TD1671394
Big Falls 2.4kv
CCD: 7-24-2026

PROPOSED CONSTRUCTION (LOCATION)
PIF#131028 – 2021 GRID RESILIENCY – BIG FALLS 2.4KV
VARIOUS LOCATIONS
FOREST FALLS, CA 92339

ASPLUNDH MAP REVISIONS IN RED 2-2-2026 JM

SHEET 2 OF 4
JOB NO. 1251109

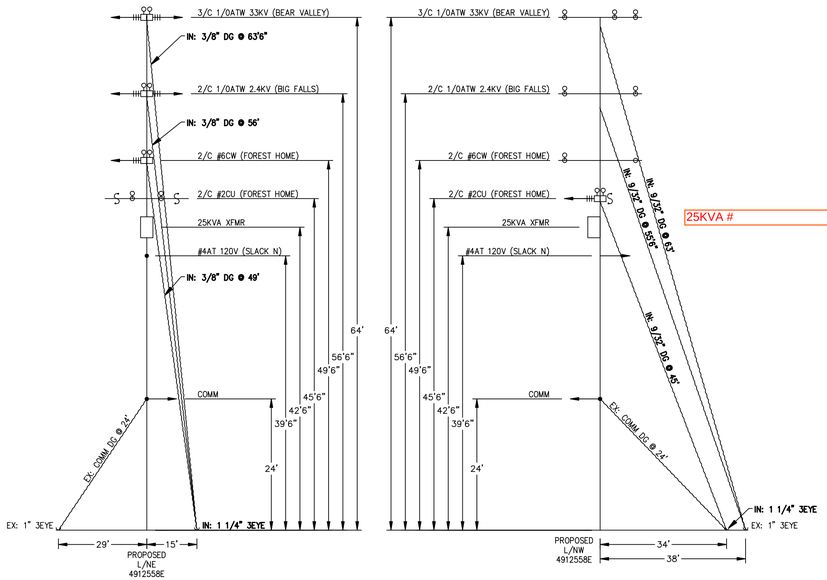
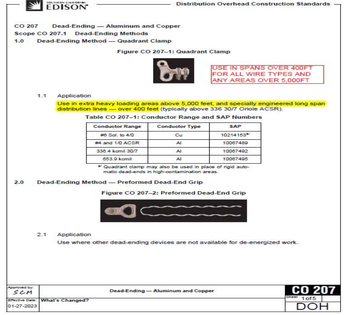
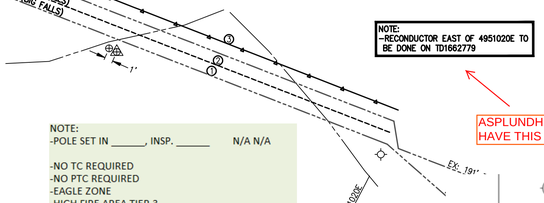
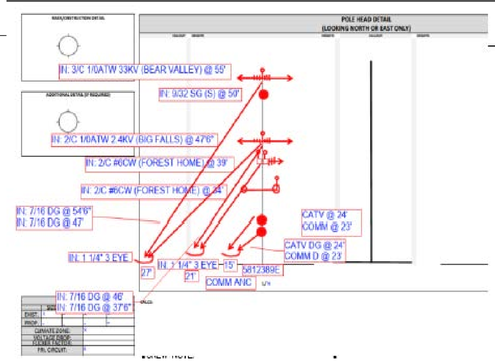
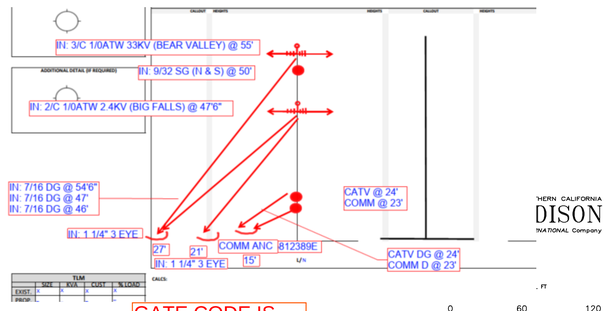
POLE,ARMS AND EQUIPMENT DONE BY OTHERS

GUY WIRE LEFT ON SITE BY OTHERS

COVERED TO BARE TRANSITION REQUIRES CONNECTOR AND DEAD END COVERS ON THE BARE WIRE SIDE

ASPLUNDH DOES NOT HAVE HAVE THIS TD

SHEET 3 OF 4

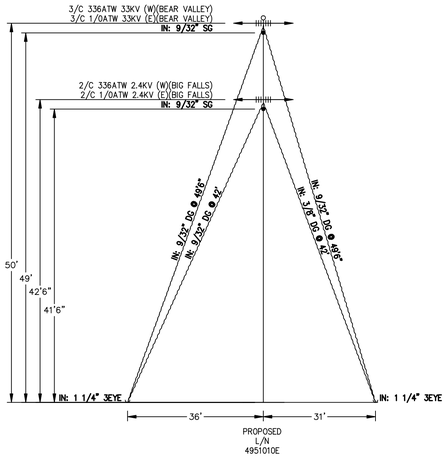
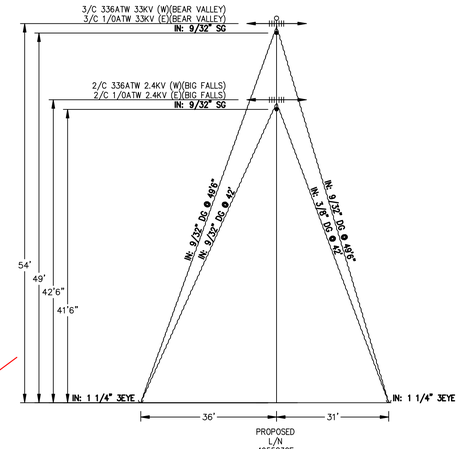
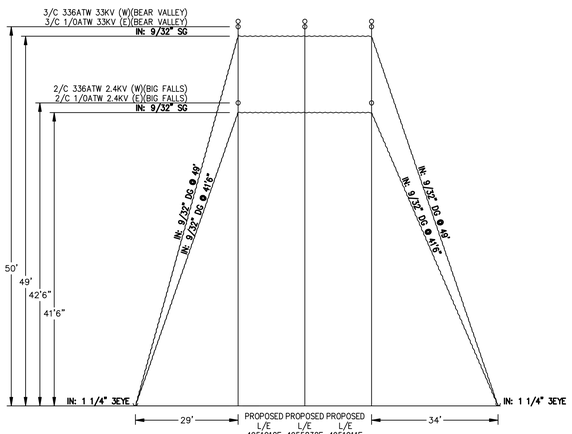
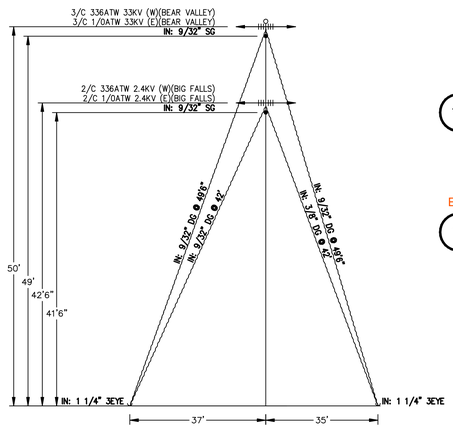
POLE AND ARMS DONE BY OTHERS

POLE DONE BY OTHERS

P# IN FIELD IS 260396B

POLE AND ARMS DONE BY OTHERS

ALL POLES ON THIS PROJECT ARE ABOVE 5,000FT HEAVY LOADING AREAS
DOUBLE COMP ARMS ARE TO BE INSTALLED ON EVERY STRUCTURE EXCEPT EQUIPMENT ARMS
V BRACES REQUIRED WITH V BRACE BRACKET WITH 4X4 WASHERS TOP AND BOTTOM
6X6 WASHERS ON ALL 12ft DEAD END ARMS TOP AND BOTTOM OF ARM AND V BRACES
POST POLYMER INSULATORS MUST BE USED WITH WASHERS TOP AND BOTTOM
PISTOL GRIP SHOES ARE REQUIRED ON EVERY PRIMARY DEAD END STATION
CENTER LINE DEADENDING REQUIRED ON HARD DEAD END AND CORNER POLES

SHEET 4 OF 4 | JOB NO. 1251109

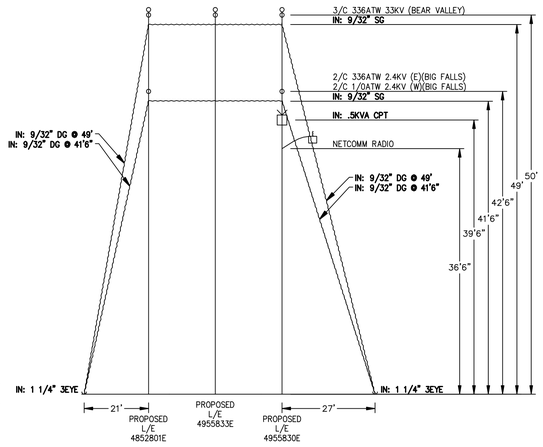
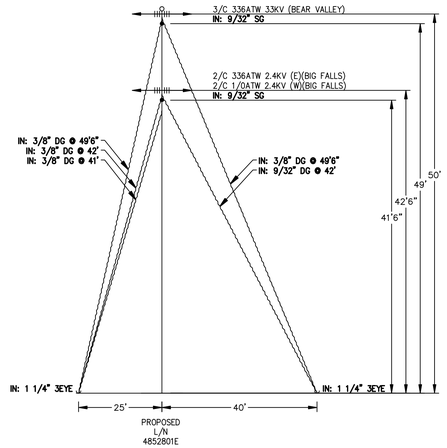
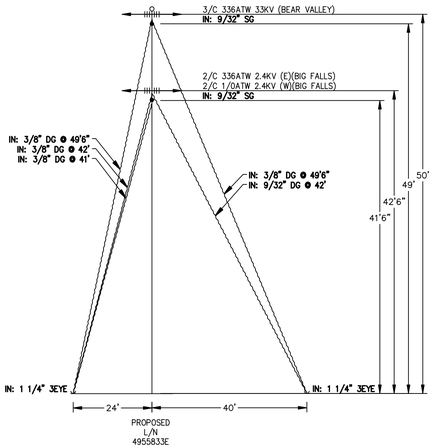
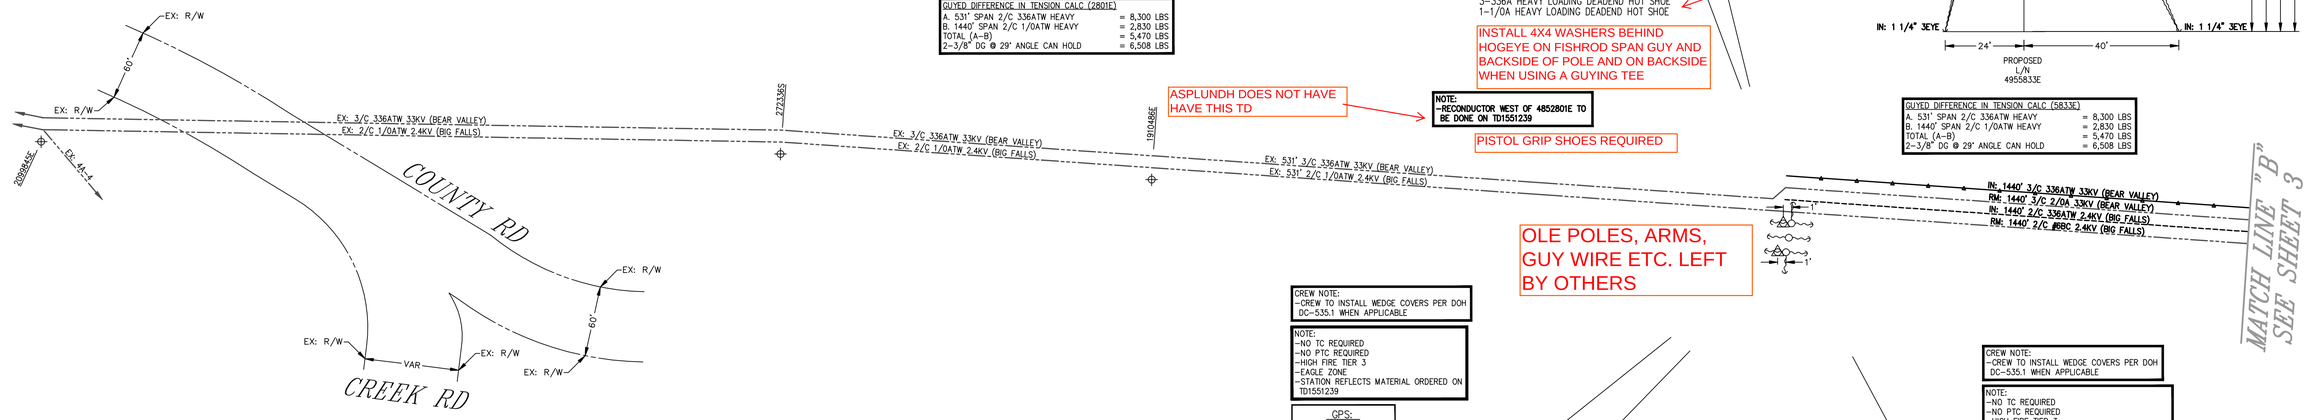
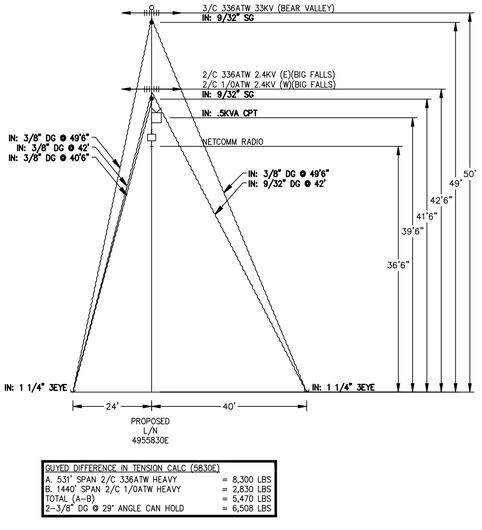
ASPLUNDH DOES NOT HAVE HAVE THIS TD

OLE POLES, ARMS, GUY WIRE ETC. LEFT BY OTHERS

POLE,ARMS AND EQUIPMENT DONE BY OTHERS

COVERED TO BARE TRANSITION REQUIRES CONNECTOR AND DEAD END COVERS ON THE BARE WIRE SIDE

POLE AND ARMS DONE BY OTHERS
